AH04505 March 9, 2004

SUBJECT: Chip indicator (contamination switch) at the main pumps

PARTS & SERVICE NEWS

Example

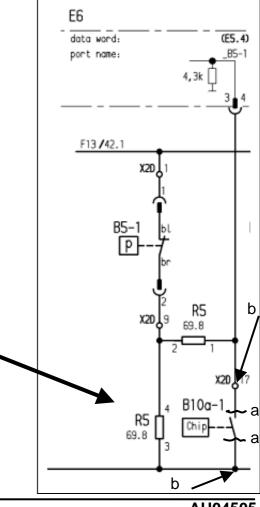
For simplification of the monitoring system and avoicance of error messages the chip

indicators are not more used in the hydraulic system.

1. Remove the cable of the chip indicators (a) and insulate it carefully (or remove it at the X2 board (b) - refer to the electric circuit diagram).

- 2. Replace the chip in licators with:
 - cover plug (7.1) 767 448 73) and
 - seal (2) 767 433 73).
